Product Change Notice (PCN)

PCN Number: PCN-0365225R-01

Product(s) Affected: SDI36-U & SDI35-UD Series

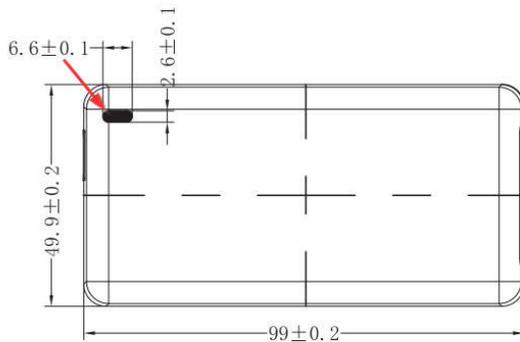
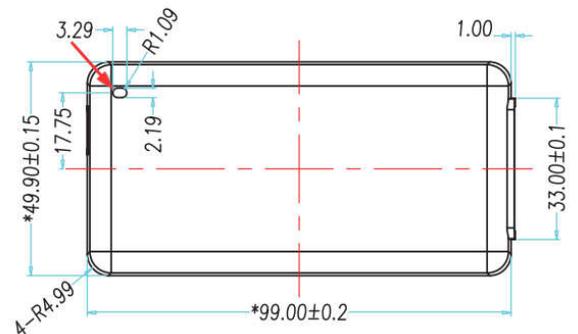
Reason(s) for Change: LED lens case tool update.

Description of Change: Size of LED lens shortened for concentrated light signal.

Additional Information: No change to fit or function. Form has been changed.
